## **City of Keene Minor Project Review Committee**

### **Pre-submission Meeting**

# PROPOSED DUPLEX

**Existing Conditions Plan of Land**

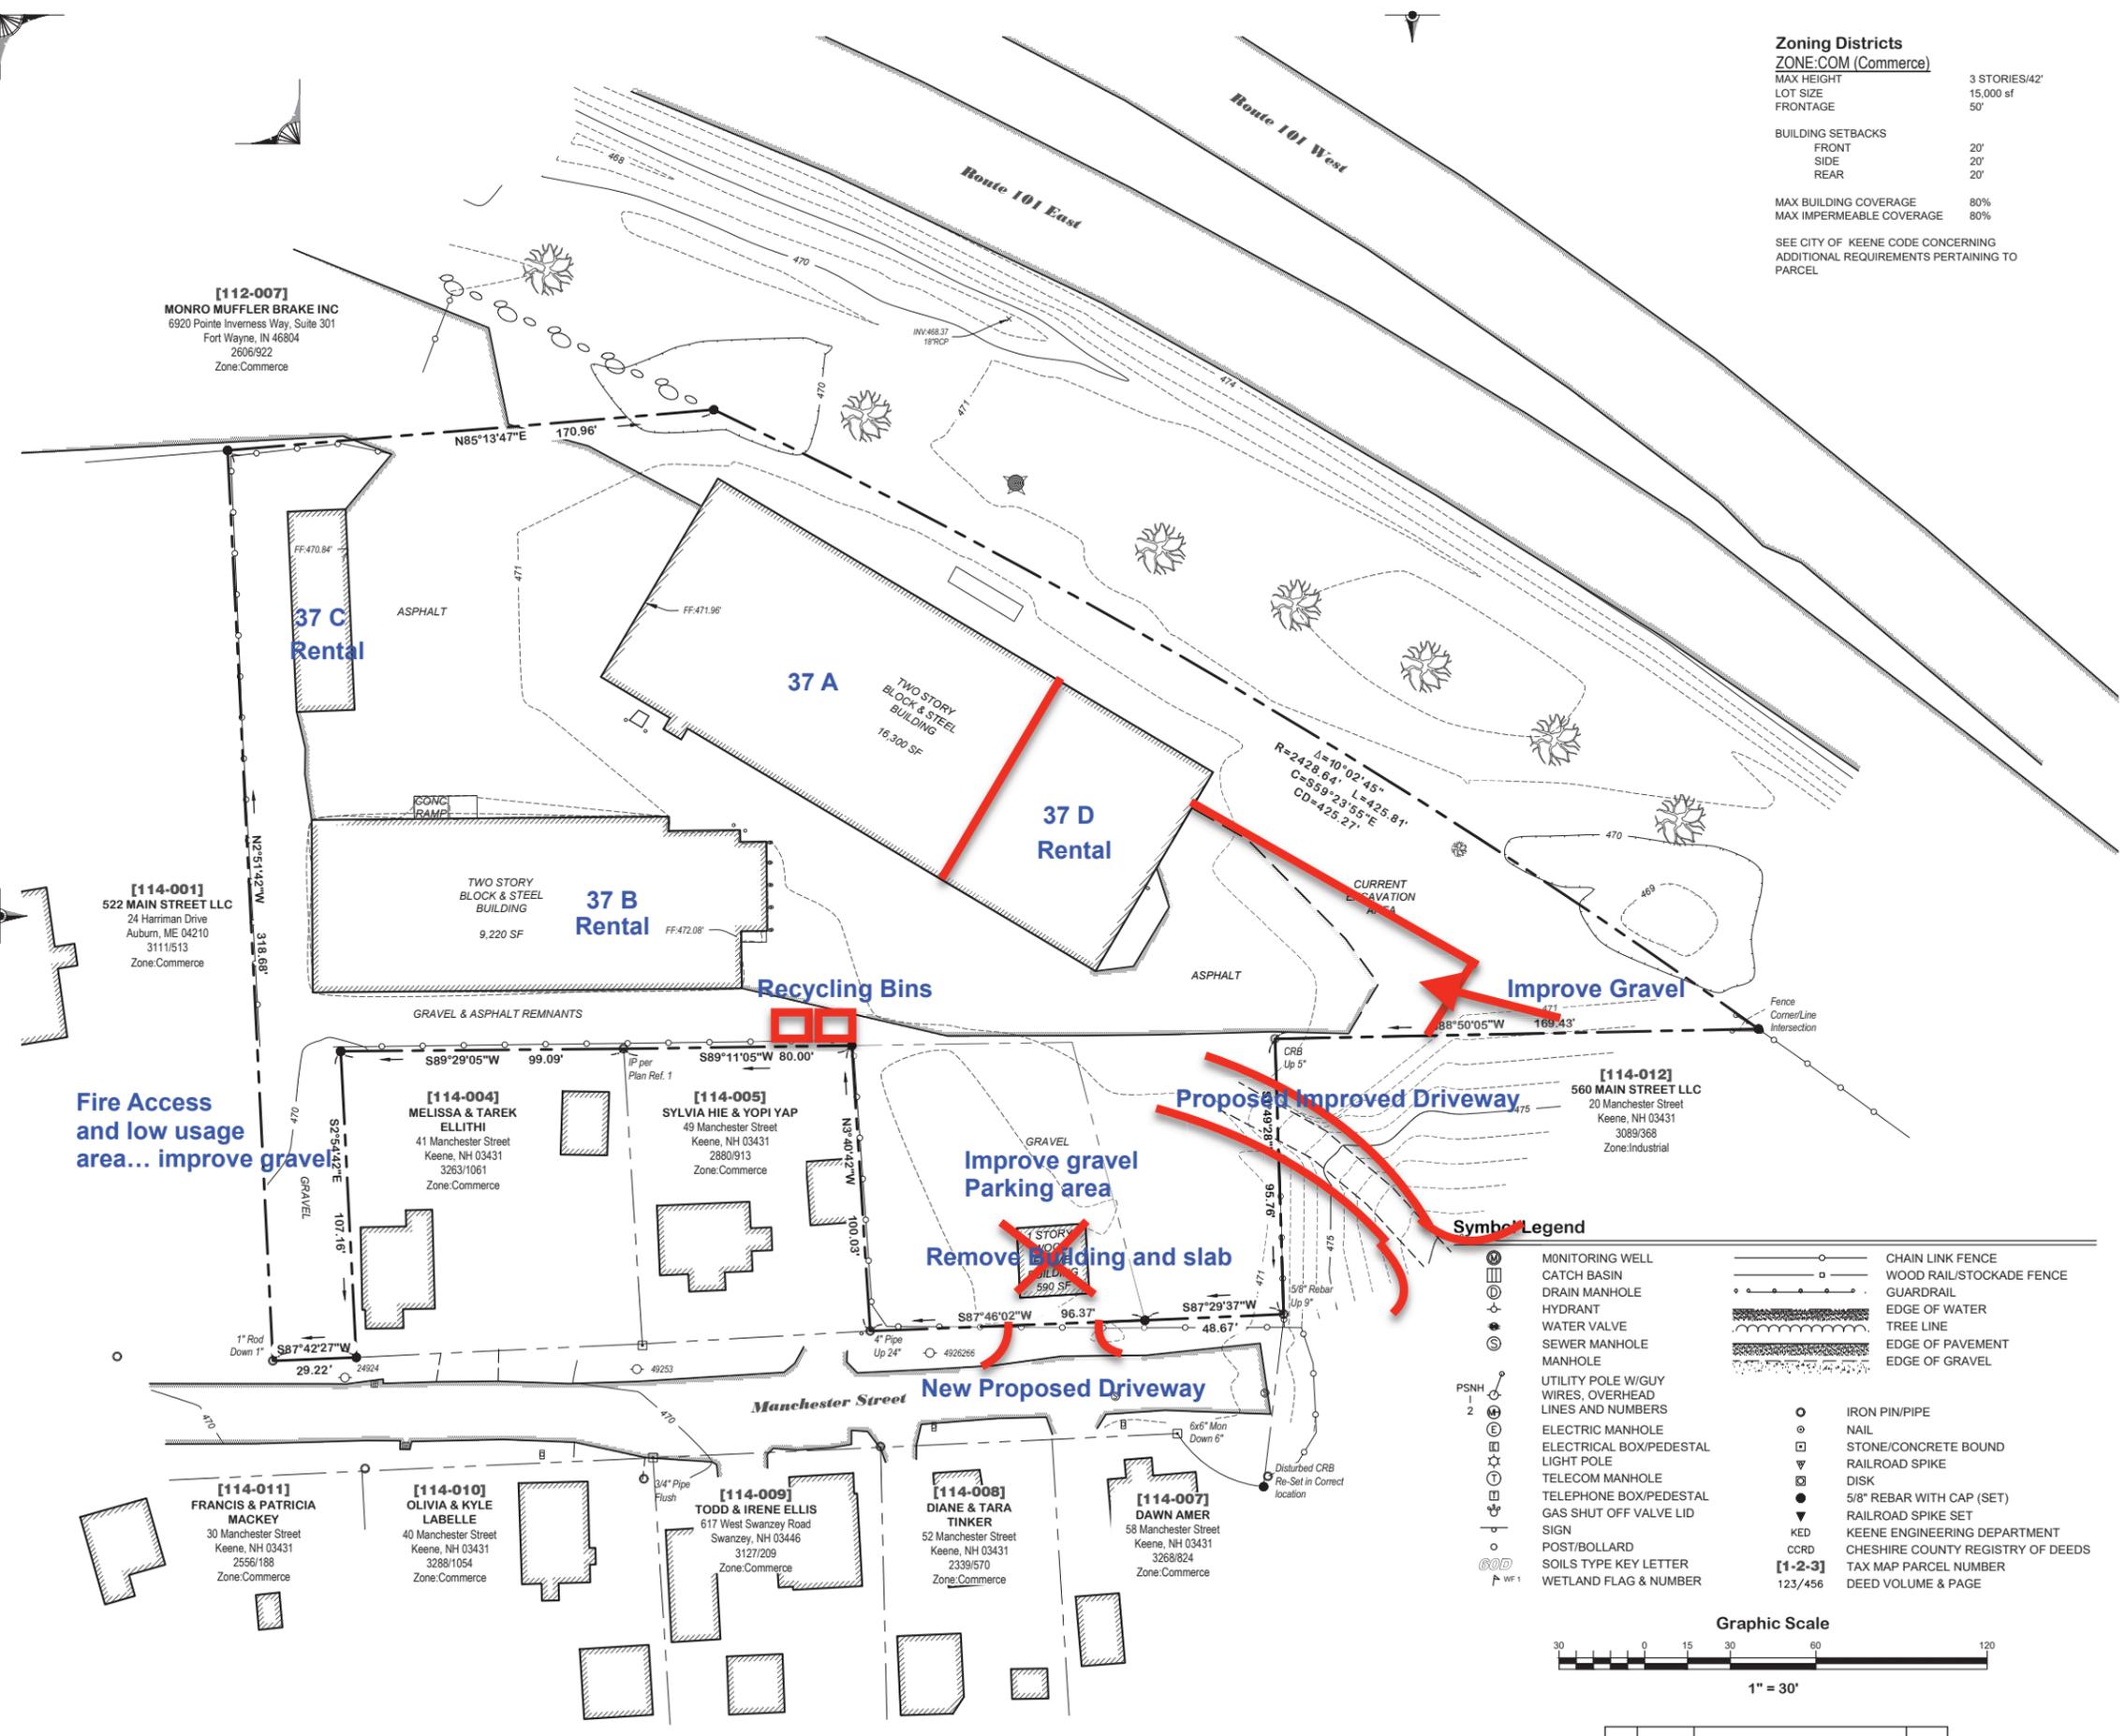
Thank you for reaching out. After discussing with the Community Development Director, we have determined that these proposed modifications to site, including changes to traffic patterns and the potential for impacts to the Manchester St neighborhood, will require Major Site Plan review by the Planning Board. We will add this application to the Pre-Submission meeting agenda for Thursday.

Please be aware that the proposed drive aisle connecting the industrial property with the commercial property will need to meet the requirements of Section 9.4.2.A (copied and pasted below). In addition, do you know whether the proposed new street access on Manchester Street will be utilized by trucks?

- a. The connection shall be a minimum of 22 feet in width for two-way traffic and 11 feet for one-way traffic, as measured along a lot line or boundary between separate properties.
- b. Connections shall be far enough from the front property line to promote vehicular and pedestrian safety.
- c. The connection shall be an extension of a travel lane of the subject parking lot and align to the maximum extent practicable with a travel lane on any adjacent parking lot.
- d. Adequate site lines shall be provided.
- e. Shared access agreements between properties shall be required where necessary.
- f. Planning review shall be required per Section 26.12.3.

Mark said the proposed new street access on Manchester Street will be utilized by cars, pickup trucks, UPS, USPS, and Fedex. Big deliveries are through the ROW through Tire Warehouse.
